Title:	Rubber Slide Pad Replacement			
Number:	PB_632	Release Date:	5/24/2023	
Revision Number:	Not Applicable	Revision Date:	Not Applicable	
Chassis Type:	107' Aerials			
Component Description:	P/N 3375632, P/N 2835961 P/N 3331833, P/N 2834343			
Warranty:	Not Applicable			
Parts:	Not Applicable			
Tools:	Not Applicable

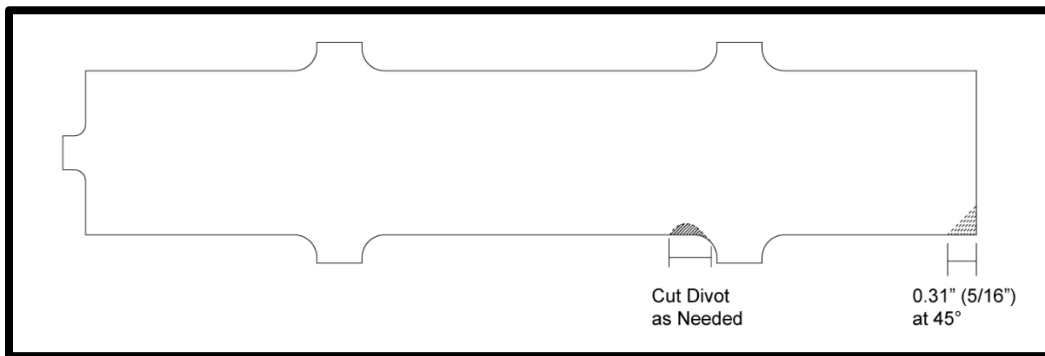
- **Rubber, Slide Pad, 3.82 x 10.25 OSL, Base (P/N 2835961)** is superseded by **Rubber Slide Pad, 3.81 x 10.25 ASL-ASP, Base (P/N 3375632)**.
- **Rubber, Slide Pad, 2.44 x 10.11 107, U-MID (P/N 2834343)** is superseded by **Rubber, Slide Pad, 2.44 x 10.11 107 ASL-110ASP, U-MID Tip (P/N 3331833)**.

Two replacements parts are not a perfect fit and will require technicians to trim the new part to fit. Use discretion to trim the soft rubber material to conform.

To make P/N 3331833 fit and be an adequate replacement for P/N 2834343. Cut angle and divot with a knife or sharp object of your choice.

Cut P/N 3331833 to fit.
